**Development Application : Discovery Point Pty Ltd
Discovery Point New Masterplan, Wolli Creek**

AERONAUTICAL IMPACT ASSESSMENT

**PROPOSED DEVELOPMENT
AT
DISCOVERY POINT, WOLLI CREEK
SYDNEY**

**PROPERTY DEVELOPMENT - DISCOVERY POINT, 1 MAGDALENE
TERRACE, WOLLI CREEK**

*Discovery Point : Wolli Creek : Proposed Development
Plan Showing Portion of the Obstacle Limitation Surfaces of Sydney Airport*

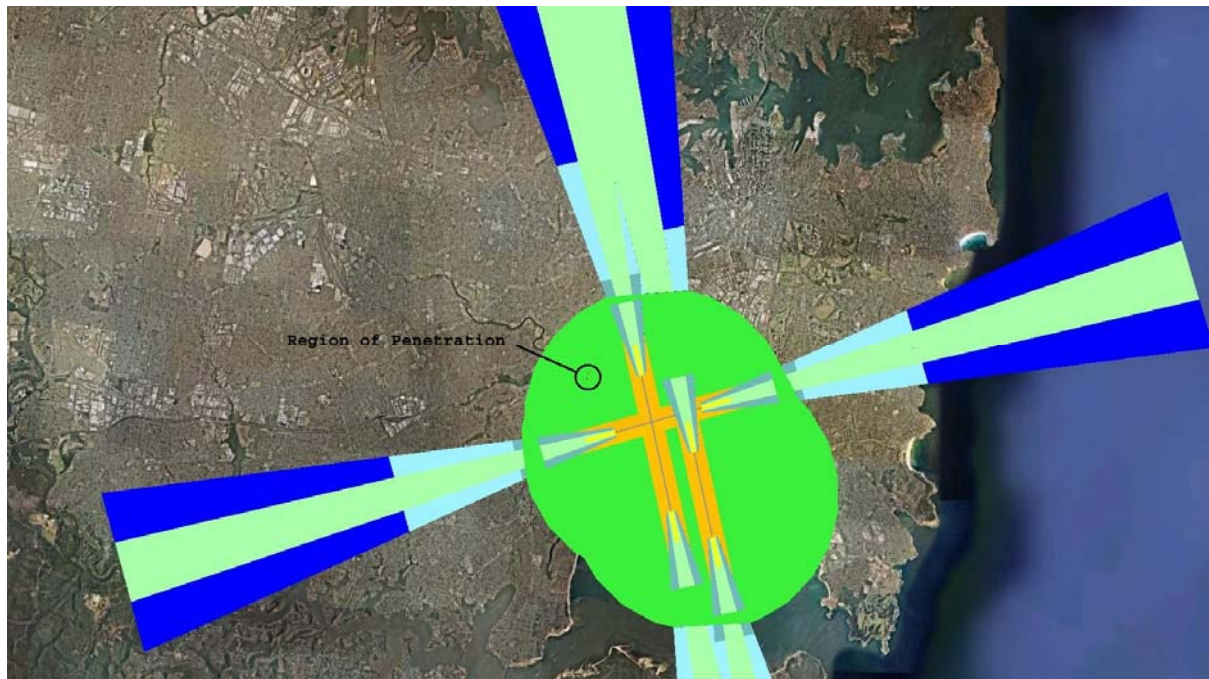
The proposed development is sited beneath the Inner Horizontal Surface and the proposed buildings will infringe the Inner Horizontal Surface by a maximum of 28.65m. An overlay diagram showing the location of infringement of prescribed airspace by the proposed development is shown at Appendix C. Table 4-1 below shows the maximum elevation of each building and the impact upon the OLS.

Note: The development site as shown is beneath the Inner Horizontal Surface (green colour) of the OLS

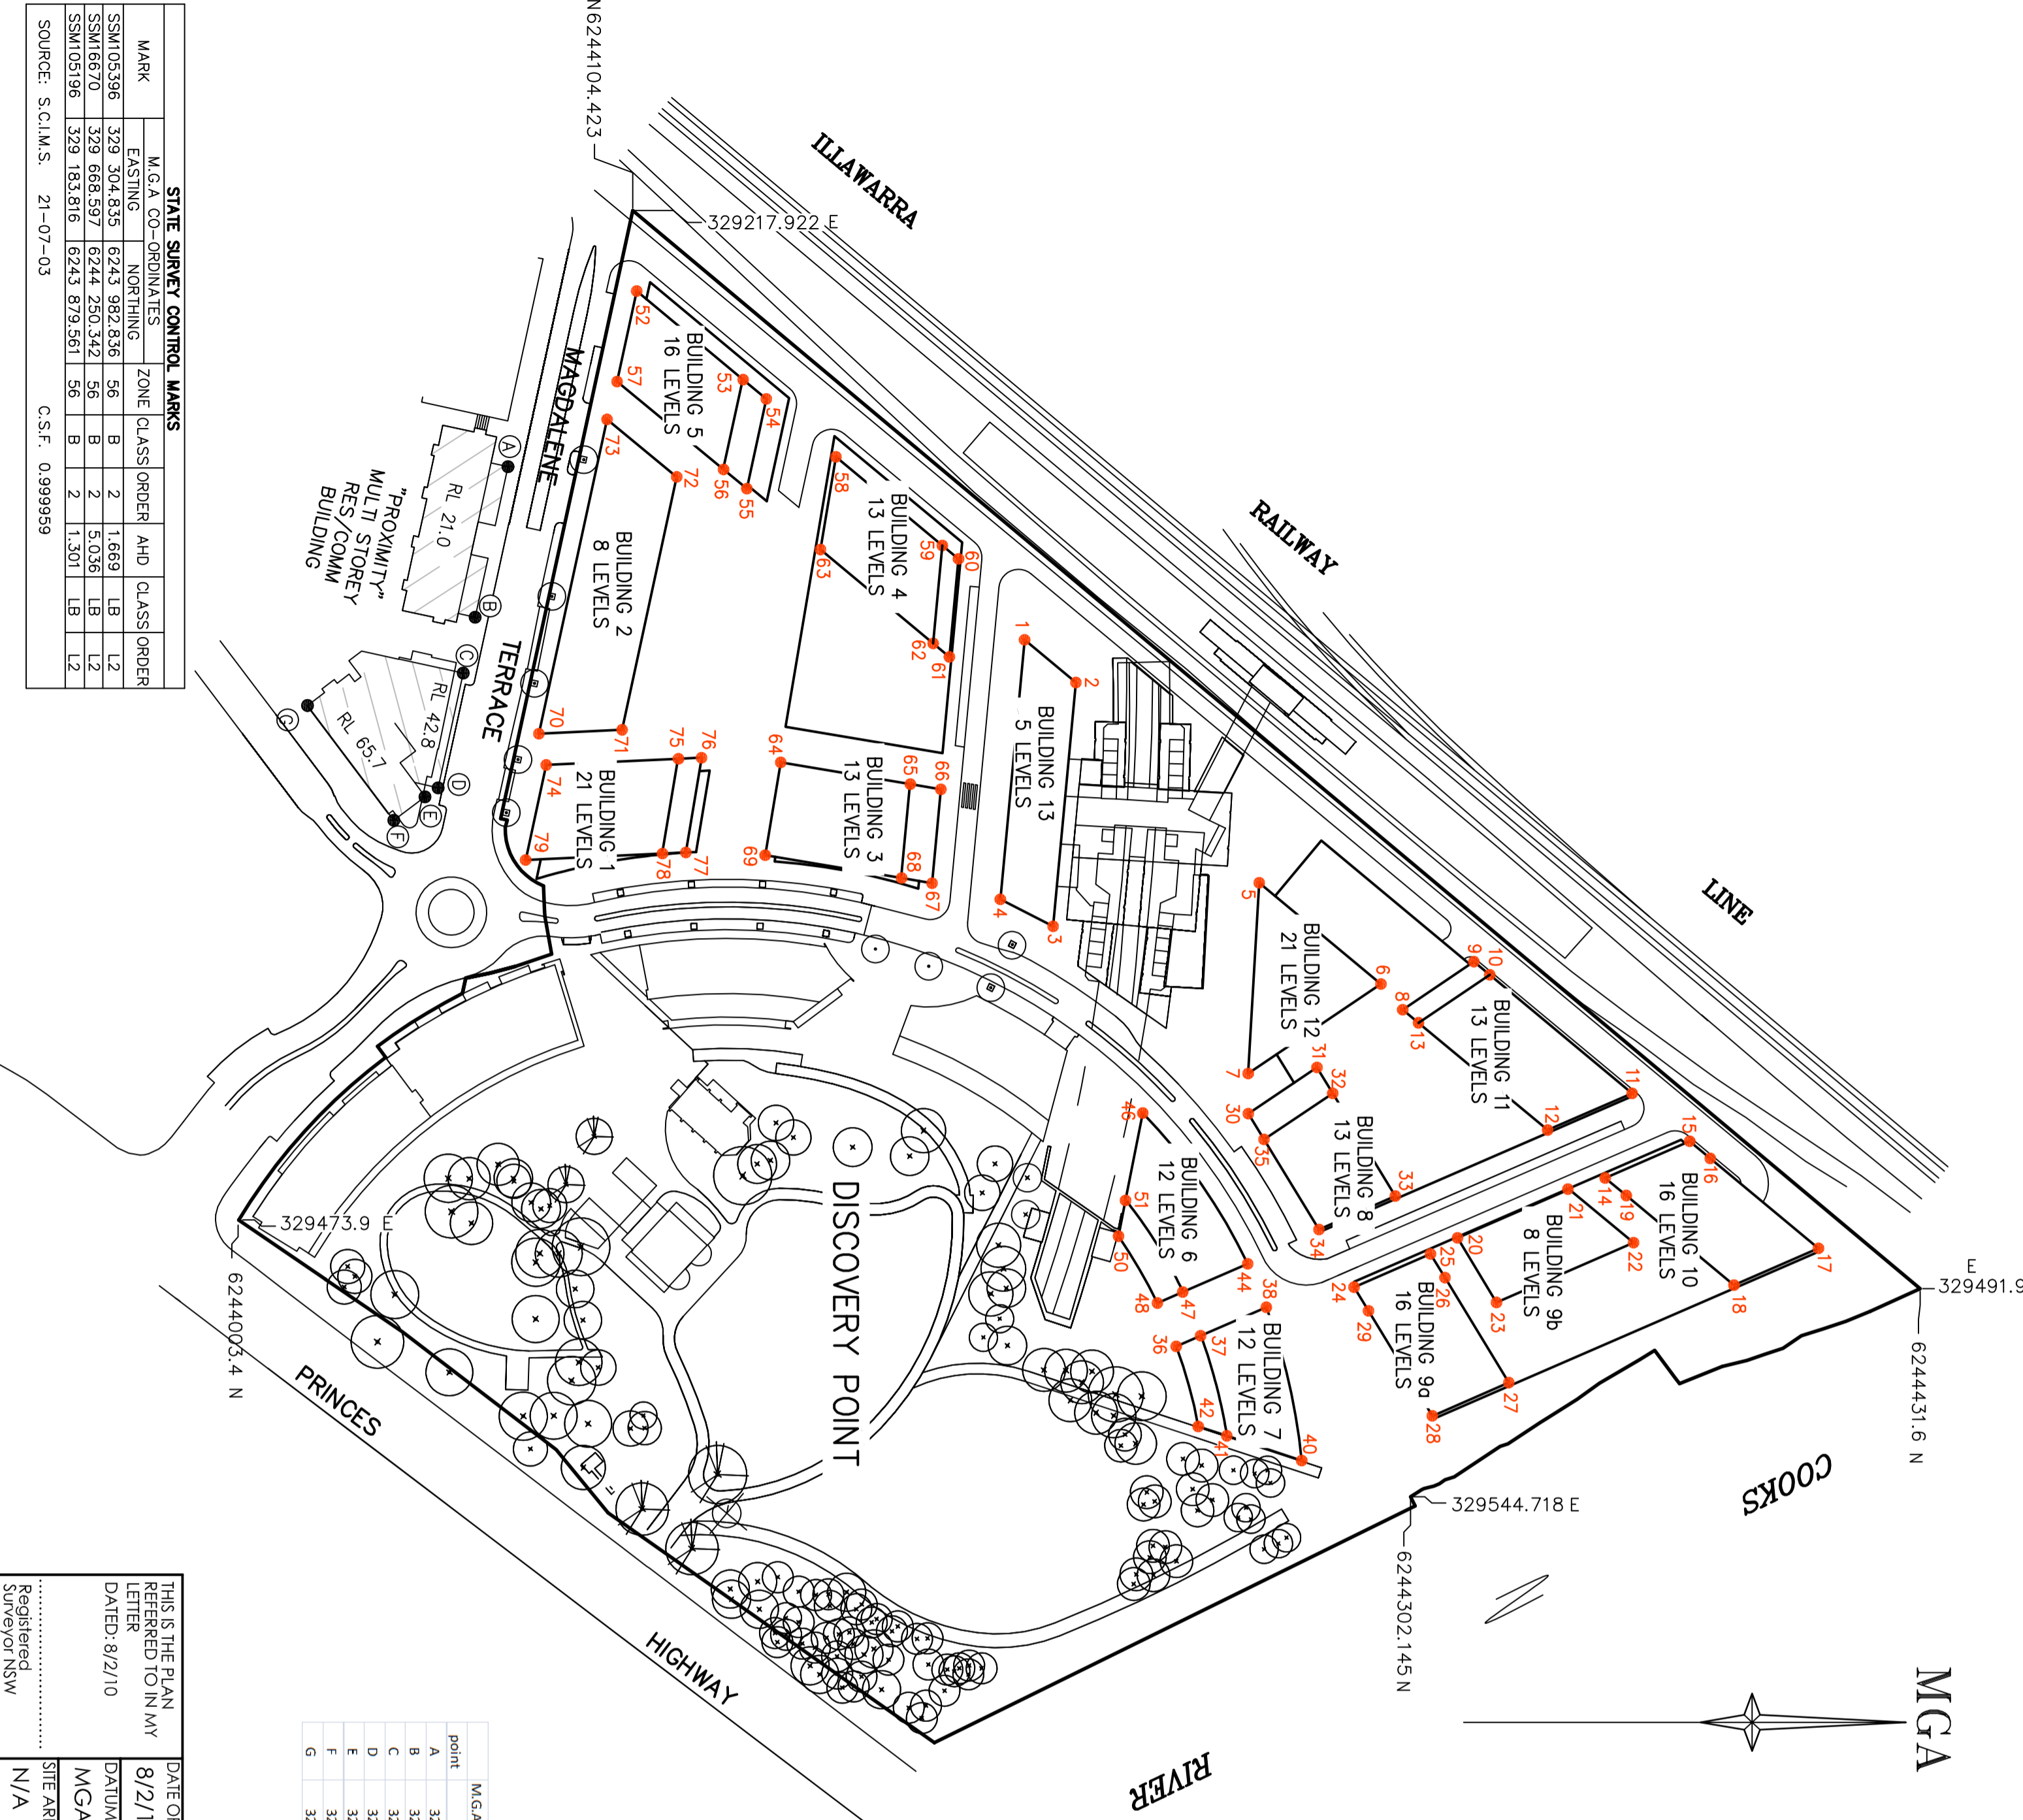
Buildings on a nearby site to the Discovery Point development are shown as having a height of 65.7m (refer Appendix A), which penetrates the IHS by 14.7m. Additionally, Planning approvals currently exist for building developments at or near the Discovery Point site that exceed the HIS.
